Seat hard to push back, second row seat (7 seater)

REF NO: TJ 32025.2.0	ISSUING DEPARTMENT: Technical Service	CAR MARKET: United States and Canada	
PARTNER: 3 US 7510 Volvo Car USA		ISSUE DATE: 2017-08-21	STATUS DATE: 2017-08-29
FUNC GROUP: 8531	FUNC DESC: Rear seat, complete	Page 1 of 6

2:nd row in 7-seater: Hard to fold back backrest

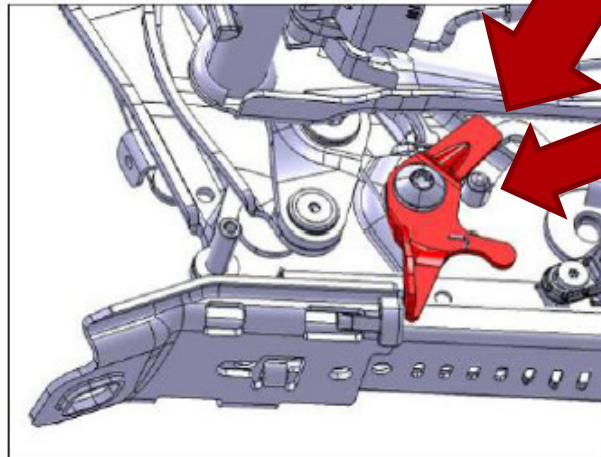
- Outer seat in 2:nd row is hard to move back after entrance to 3:rd row.
- Backrest folds back too early (before seat is slided back).

Stopping edge of rebound bracket wear against the stop screw. This wear prevents it from releasing.

- Replace the rebound bracket.
- New concept "knee lever" to be introduced.

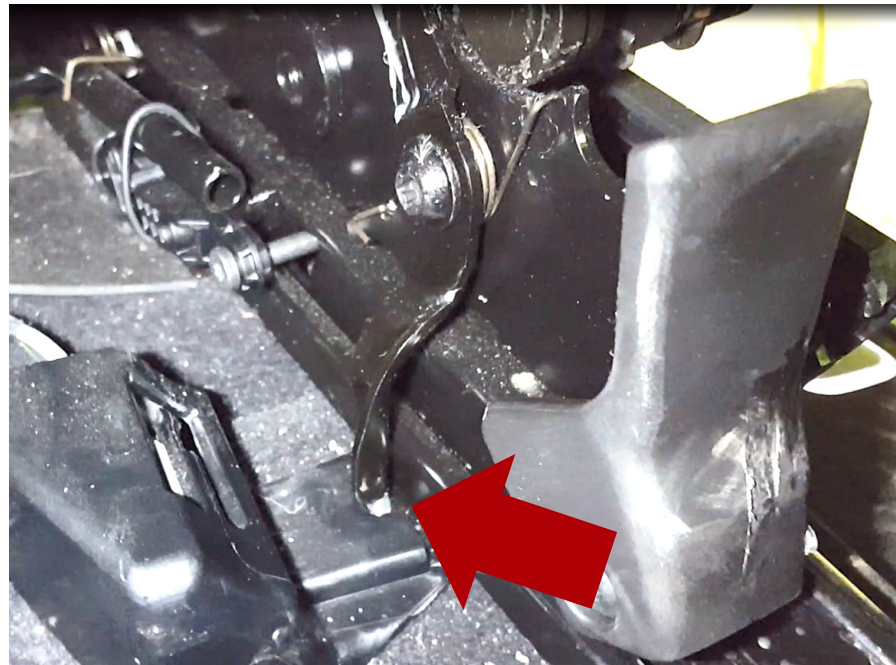
Outer seat in 2:nd row is hard to move back after entrance to 3:rd row.

Lower part of rebound bracket sticks on screw head.

- Grind down the screw head.
- New concept with lower screw head.

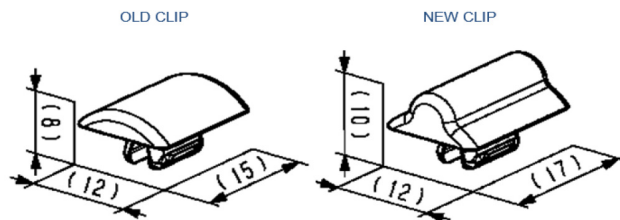
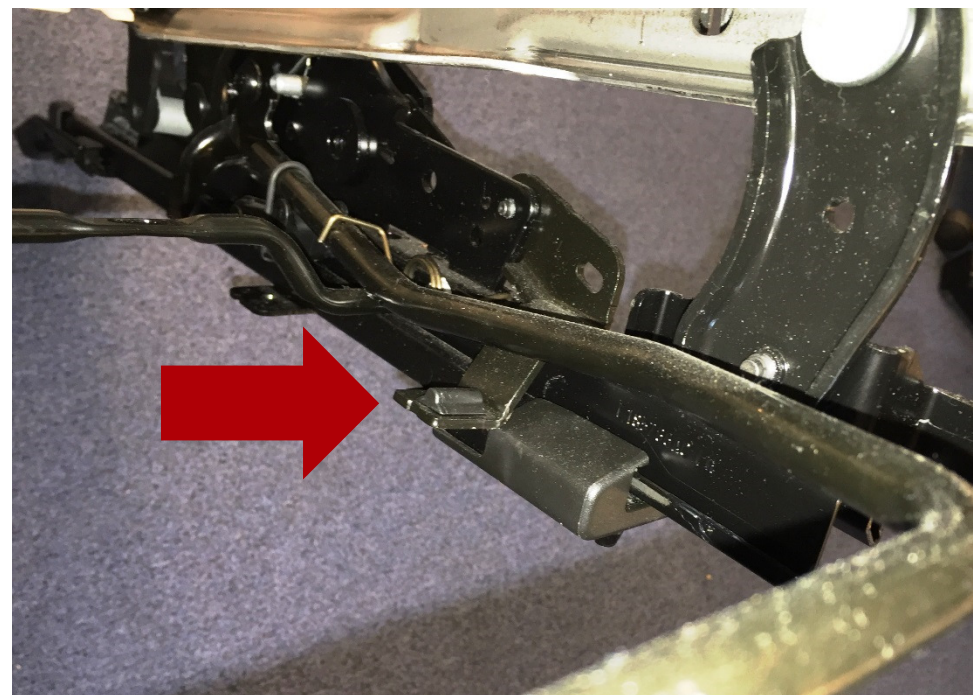
Outer seat in 2:nd row is hard to move or makes rattling noise over the rails.

Plastic stoppers for adjustment lever forward/backward too low.

Replace stoppers to new, higher model.
No p/n change.

Issue: 2:nd Row outer seat, 7 seater

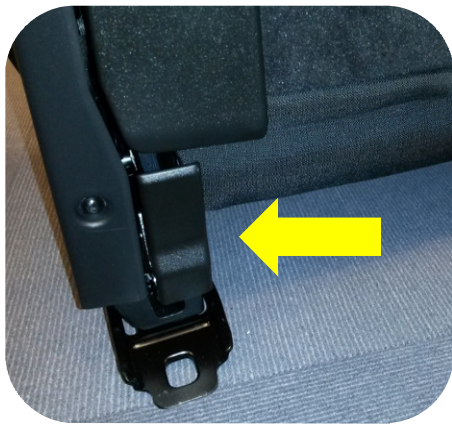
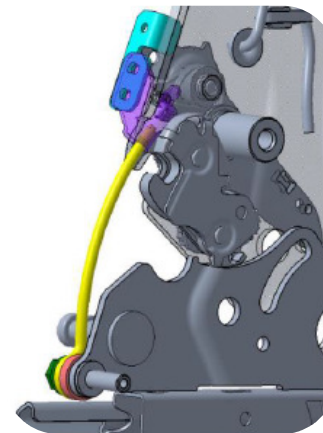
Gap closer can get stuck and damaged when back rest is folded back.
To avoid on current cars: Always start from normal position when seat are supposed to be flat folded. (Do not start from easy entry position.)

Solution step 1 Current Gap closer will be redesigned.

Solution step 2 New concept under development.
